24-DDP-0078

REZONING & SUBDIVISION
AKEN NORTH SUBDIVISION
 16907, 16907R, 16909 & 17140
 T.B. 16 LOTS: 8, 19, 61, 103
 D.B. W0424, P.C. 986 & 1000
 D.B. 9057 P.C. 818 & D.B. 1000

CASE #21-ZONE-0001
 MSD WM #12220

24-DDP-0039

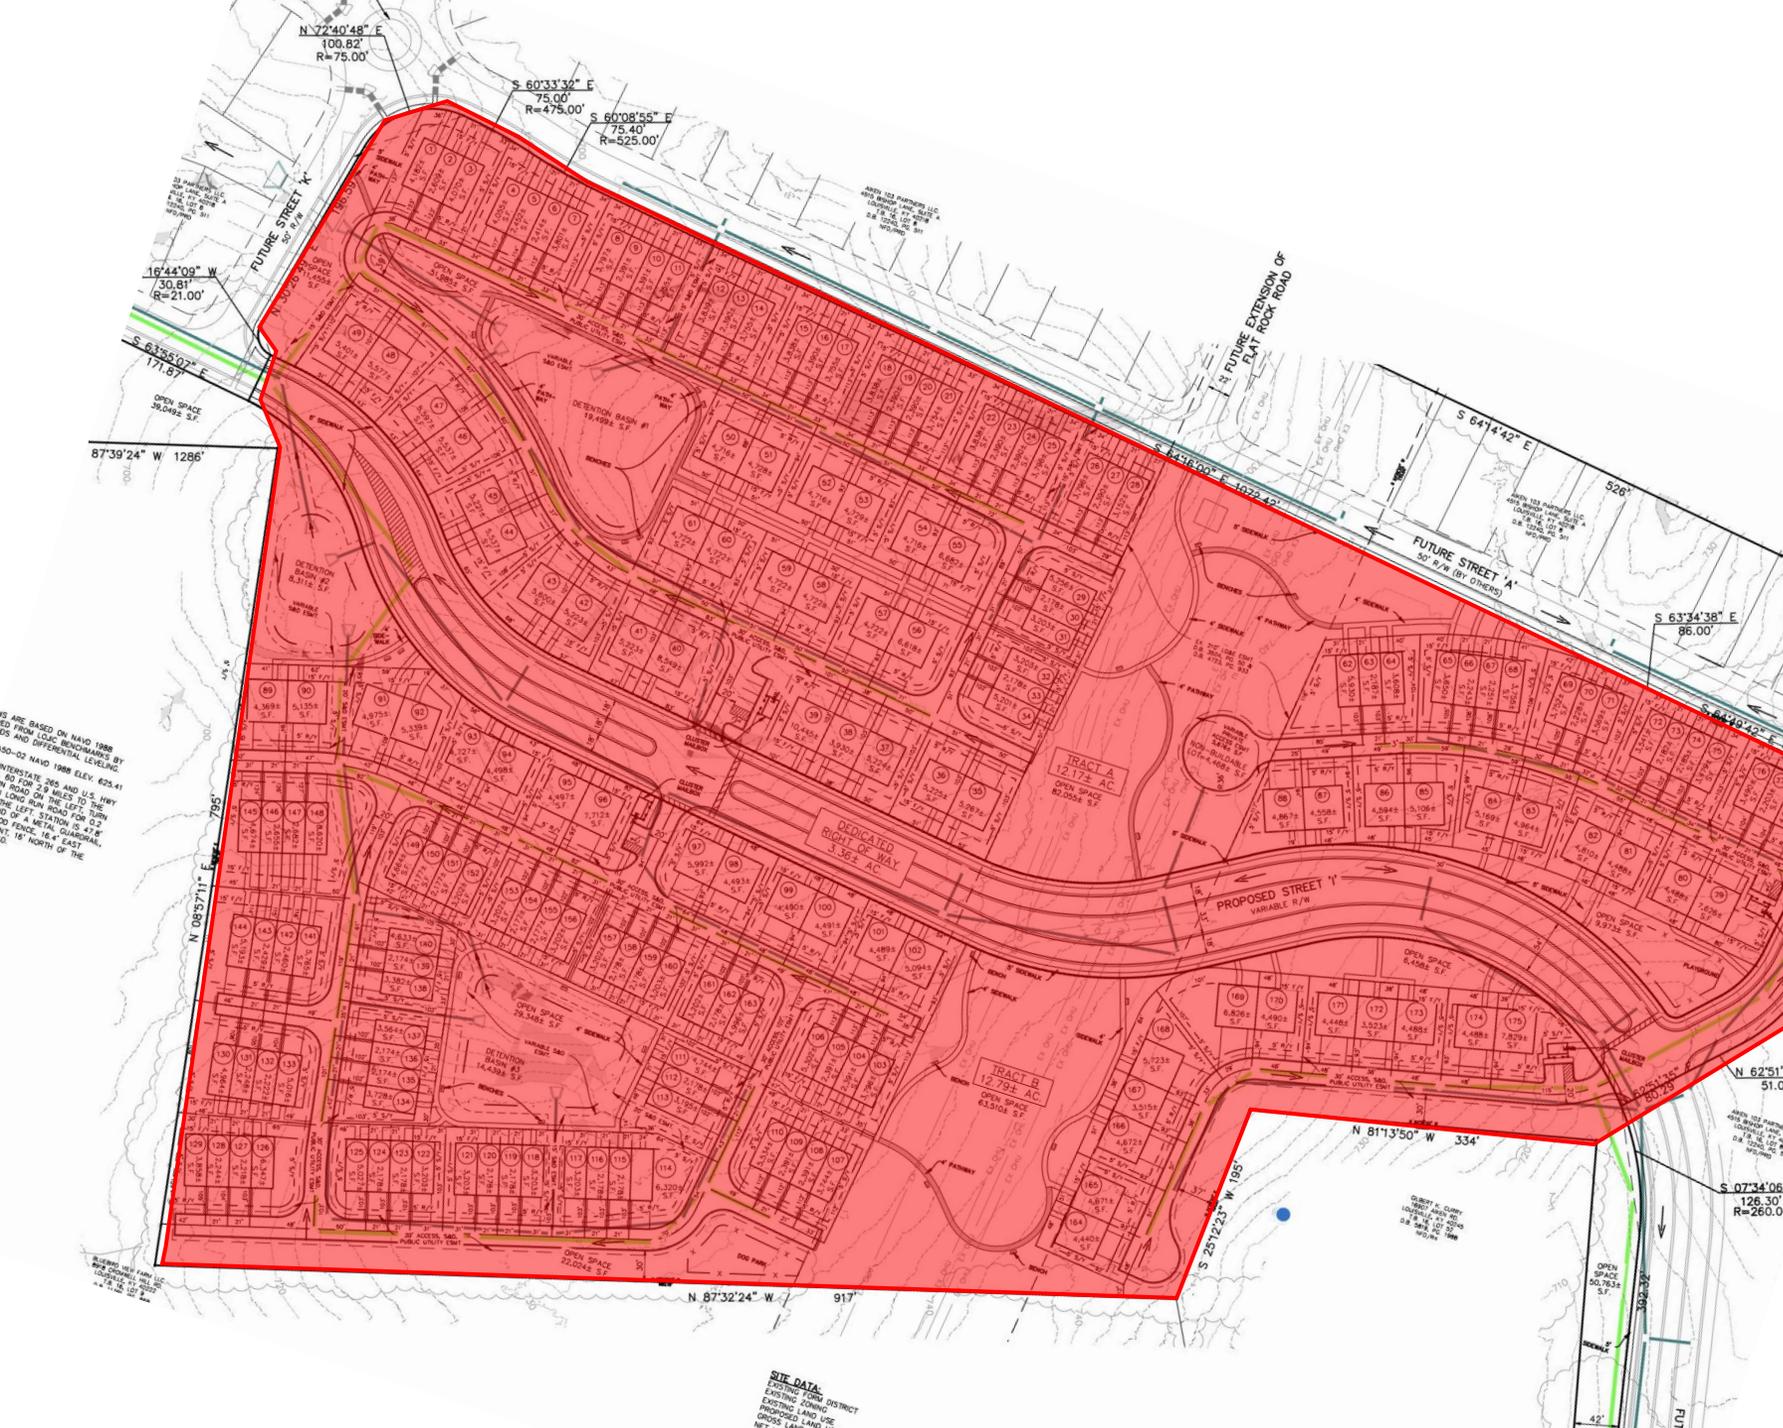
Lots

Originally Approved: 83

10/3/24 Updated: 175

DDP is **92 lots over** the 866
Plan Certain

Condition: Return in 6
months with plan to remove
the 92 from "Section 3"
nearest Floyds Fork

24-DDP-0078

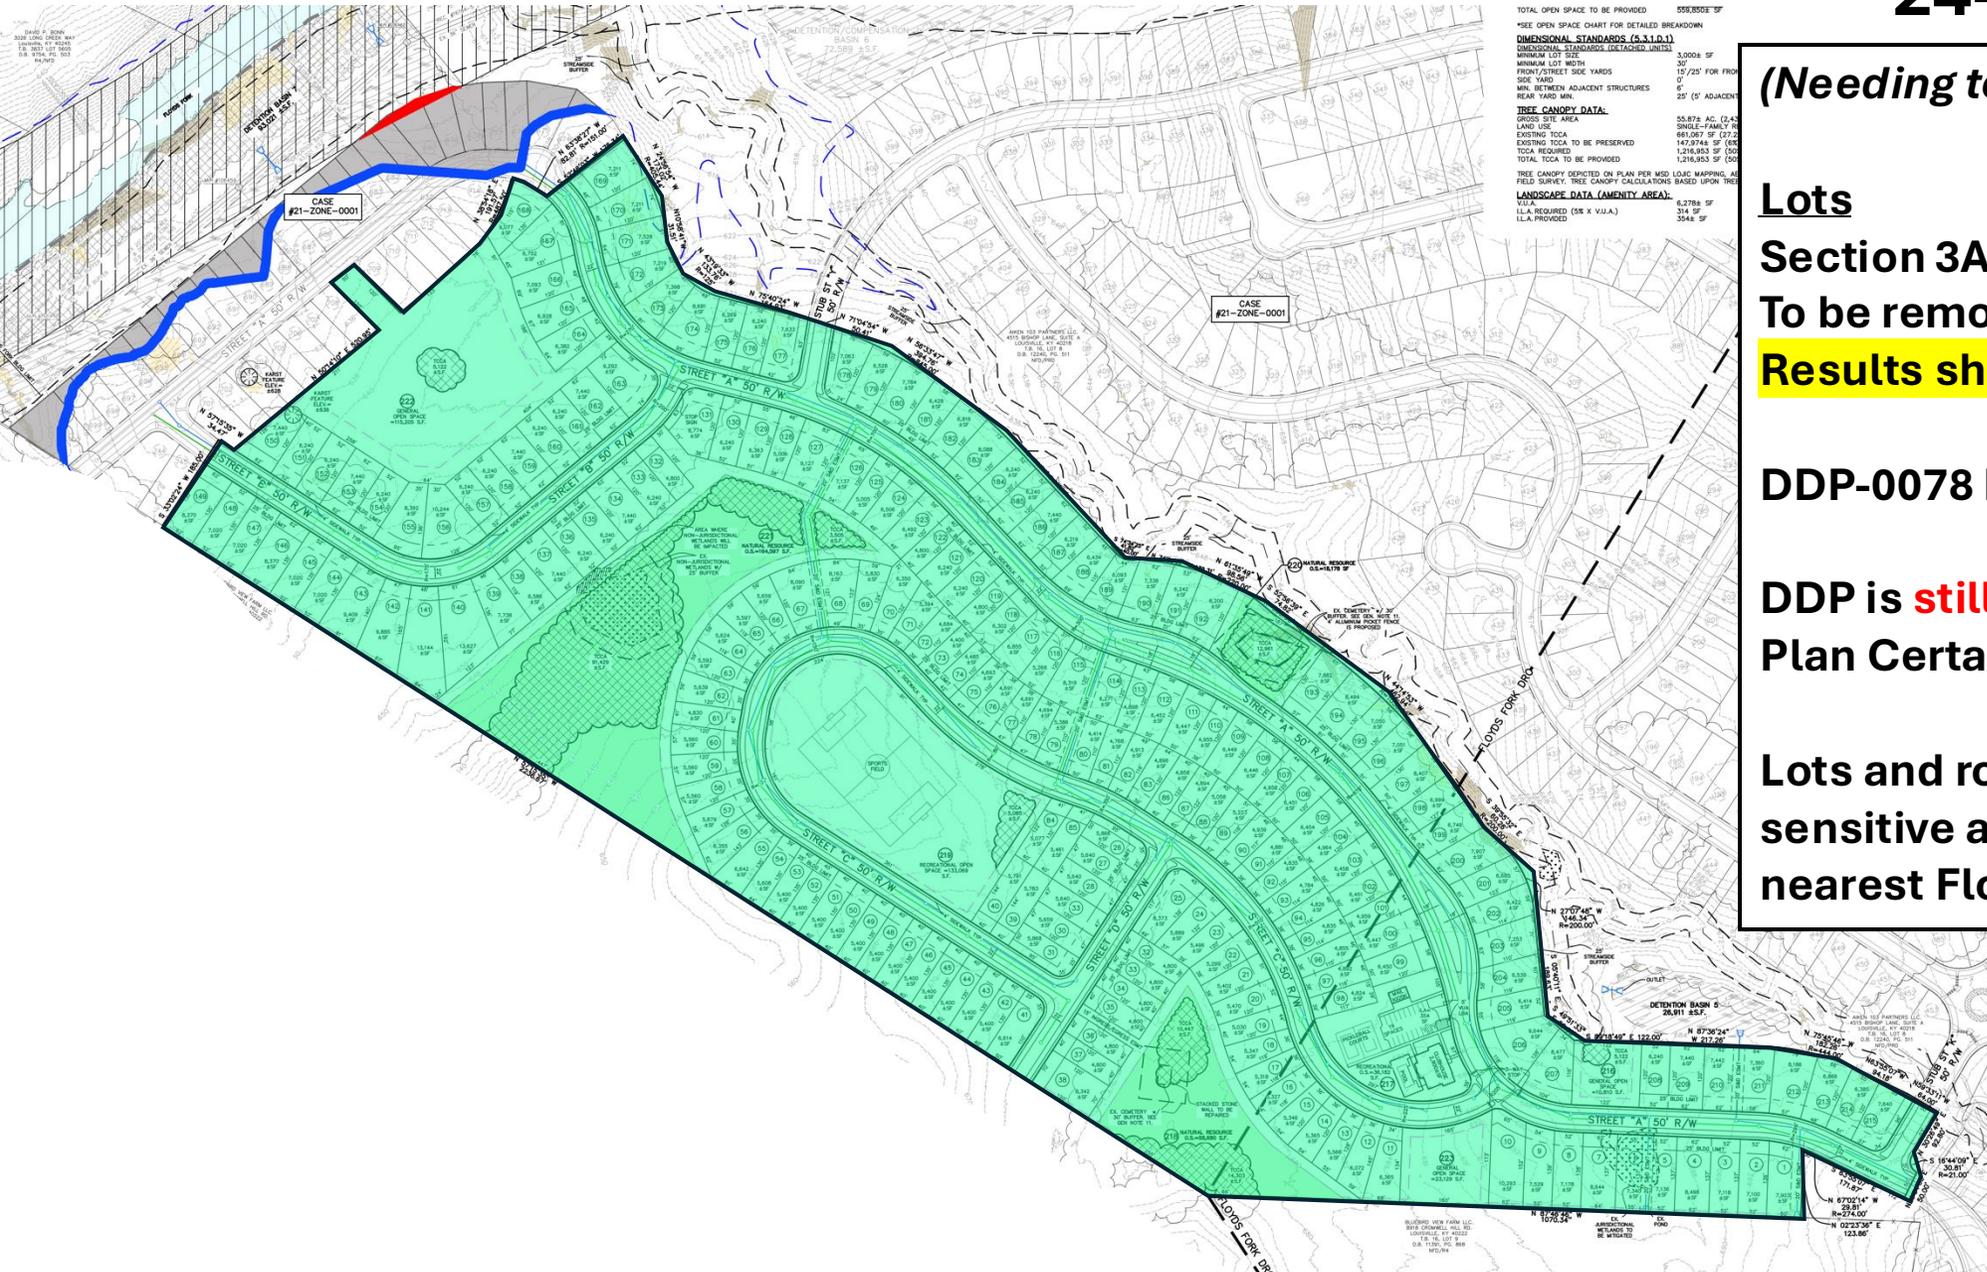
(Needing to remove 92 lots)

Lots	
Section 3A originally	286
To be removed	- 92
Results should be	194

DDP-0078 Request: 215

DDP is **still 21 lots over** the 866 Plan Certain

Lots and roadway still in most sensitive areas of "Section 3" nearest Floyd's Fork

24-DDP-0078

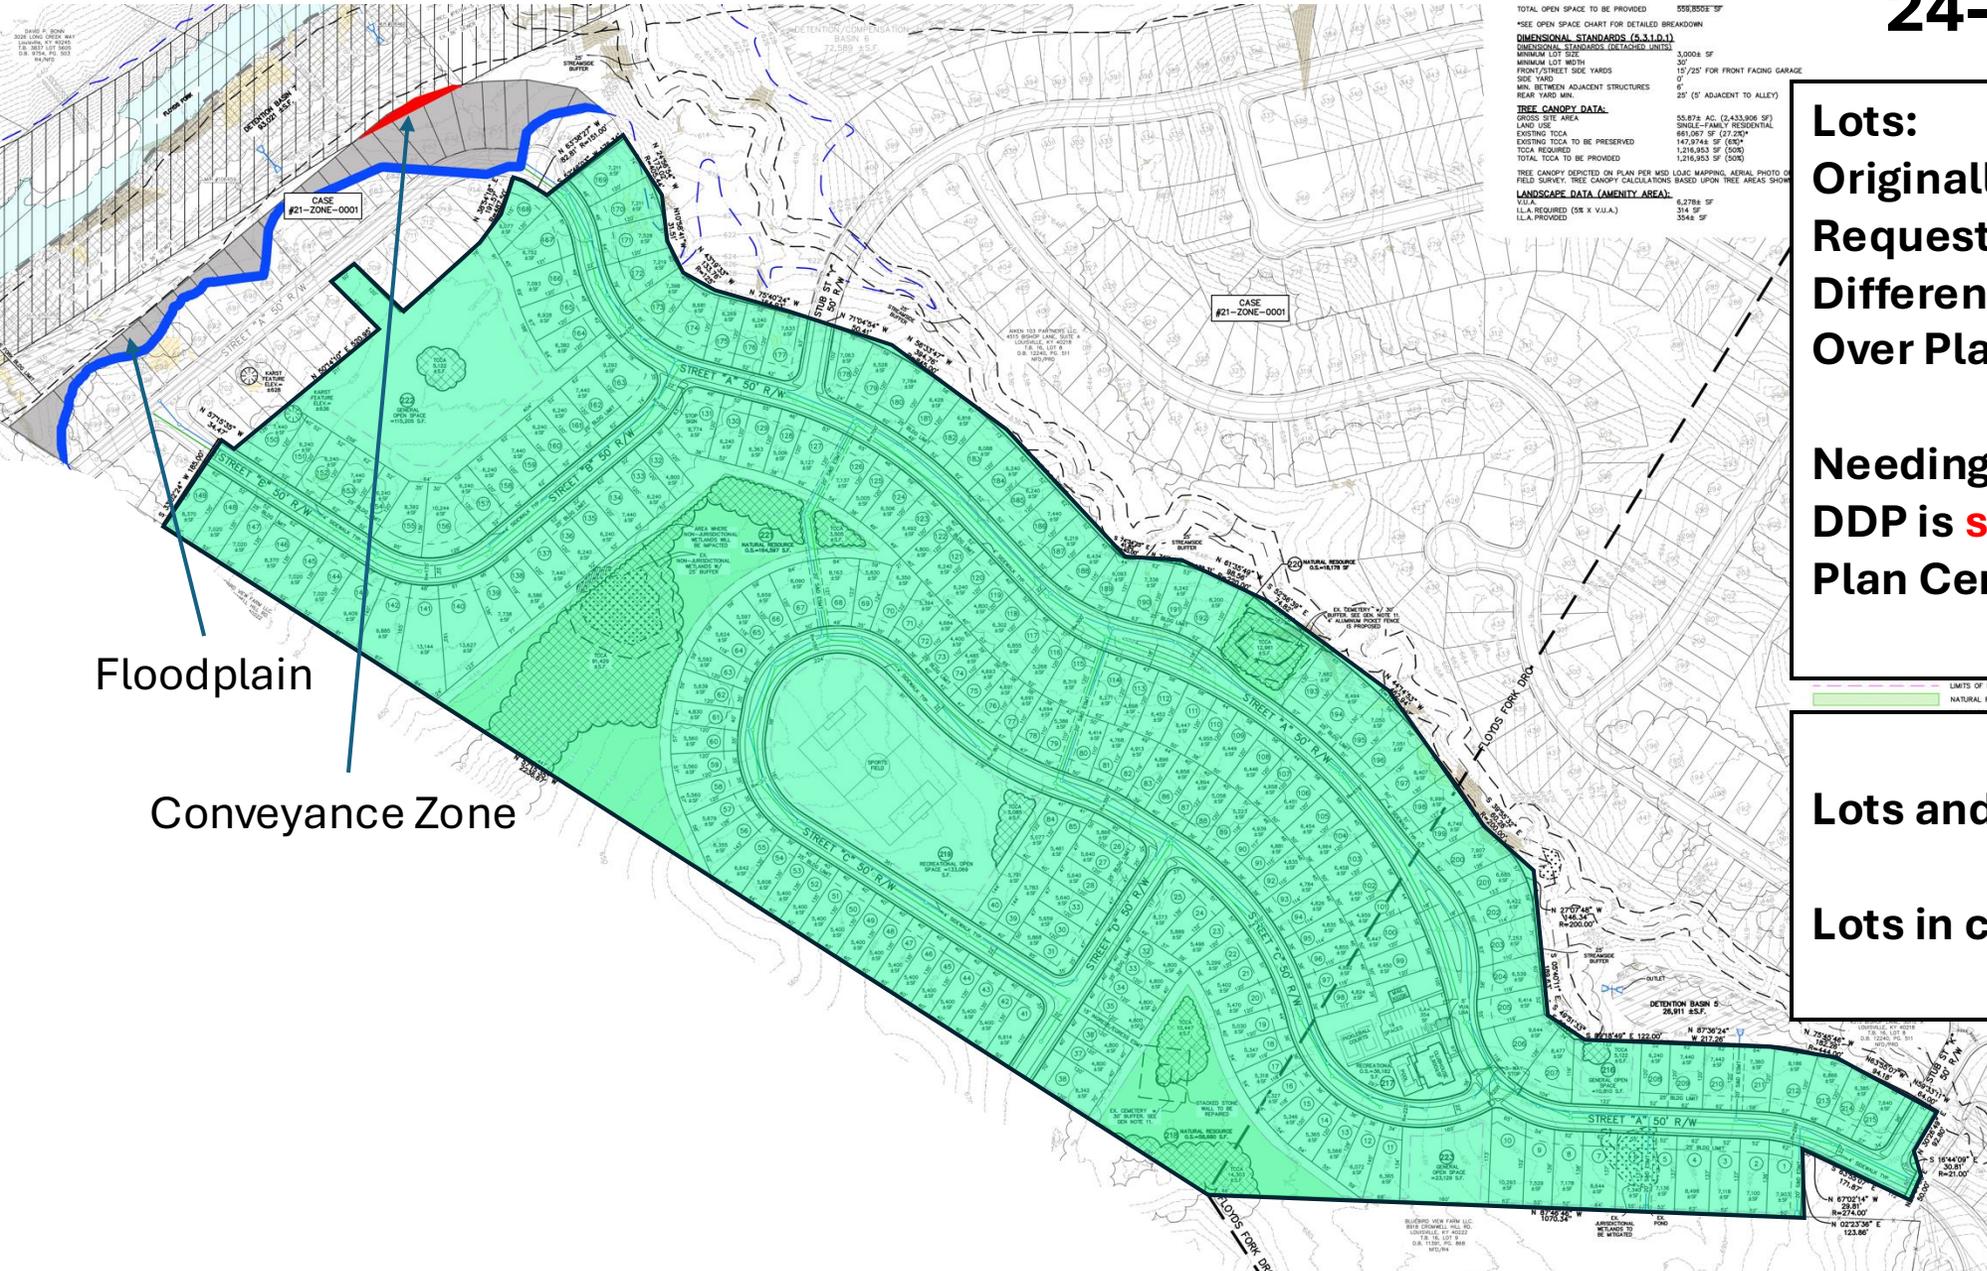
Lots:	
Originally Approved:	286
Requesting:	215
Difference:	71
Over Plan Certain:	21

**Needing to remove 92 lots.
 DDP is **still 21 lots over** the 866
 Plan Certain**

Floodplain
 Conveyance Zone

Lots and roadway in floodplains
 Lots in conveyance zone

24-DDP-0078

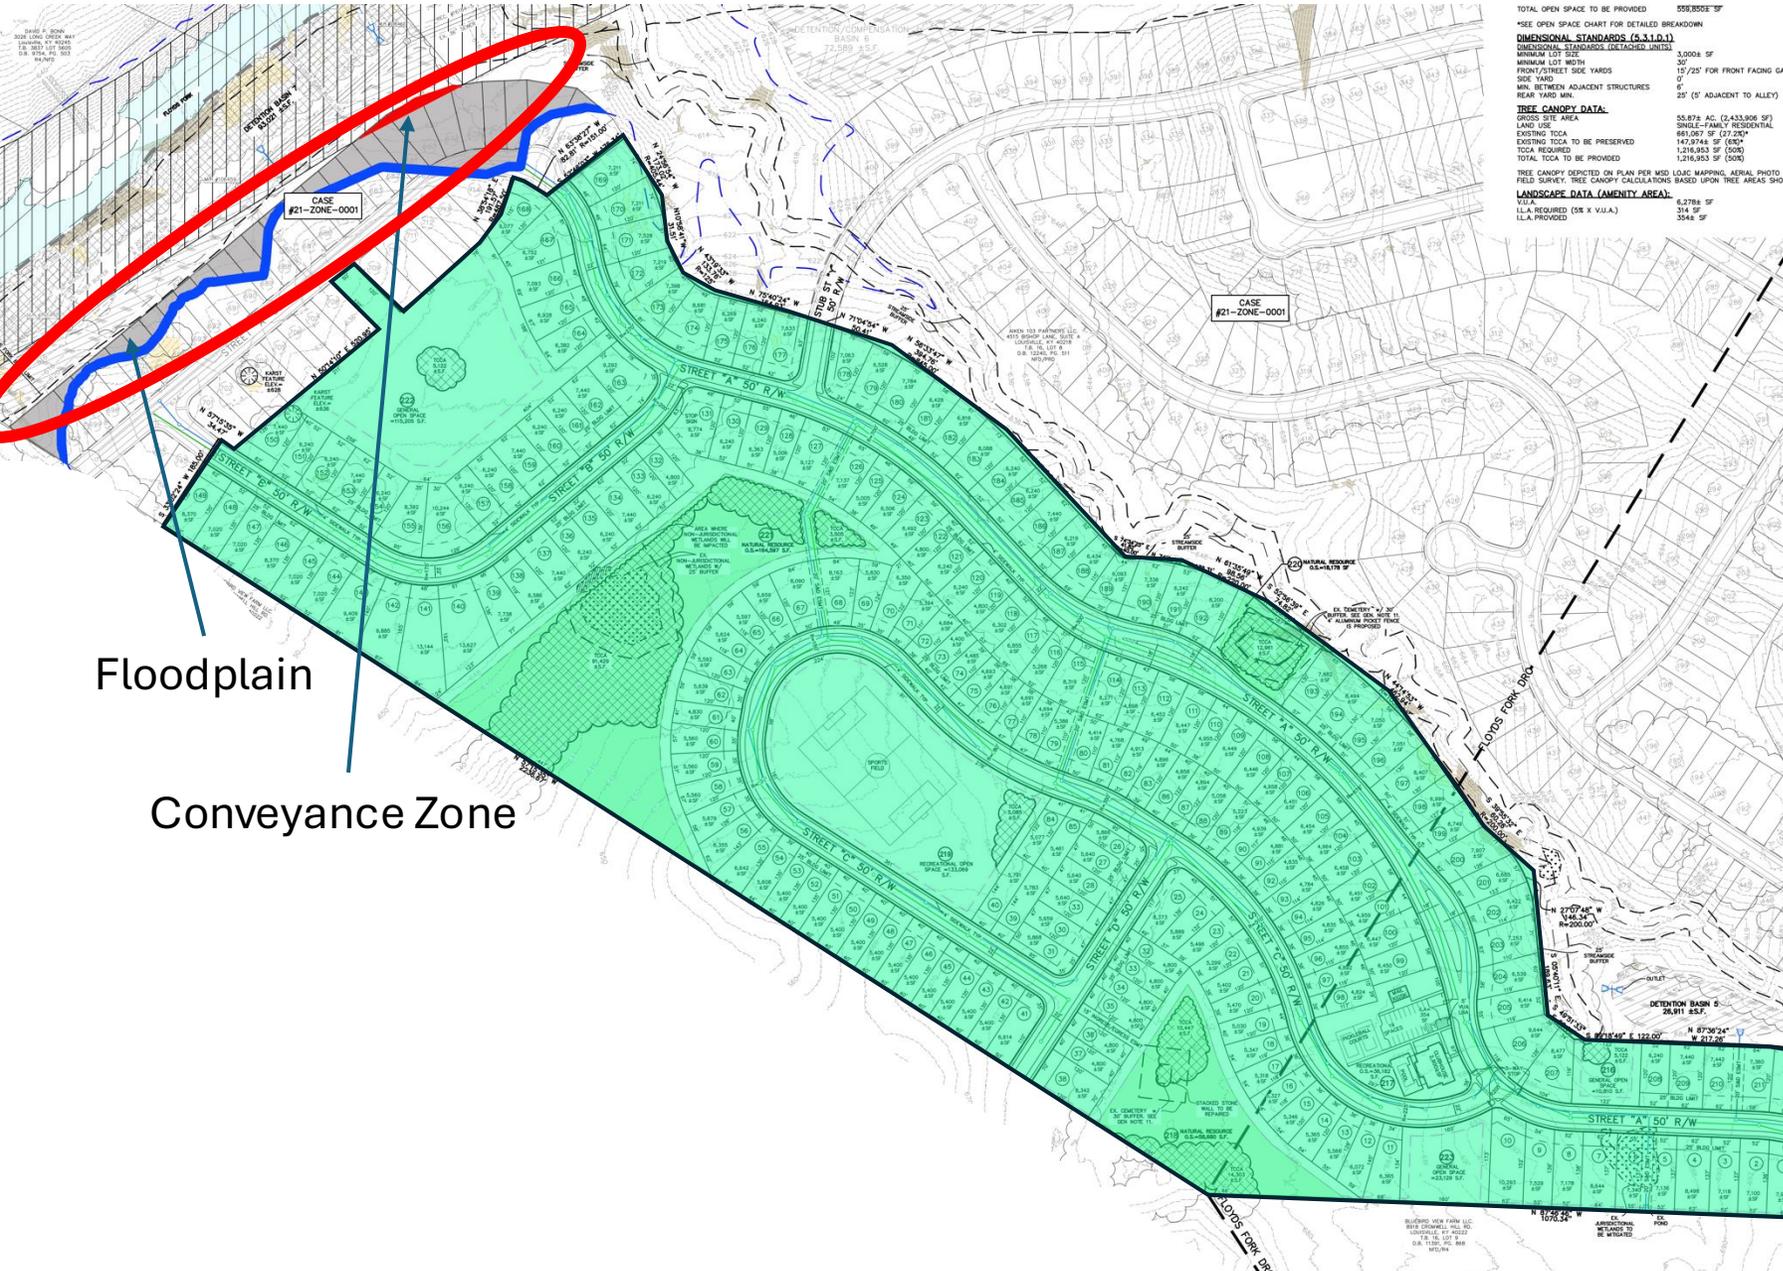
Lots:	
Originally Approved:	286
Requesting:	215
Difference:	71
Over Plan Certain:	21
Needing to remove 92 lots.	
DDP is still 21 lots over the 866 Plan Certain

Request: Deny this DDP application due to the fact they are still over the 866 Plan Certain and require the applicant to remove the 21 lots and roadway from the floodplain.

Floodplain

Conveyance Zone
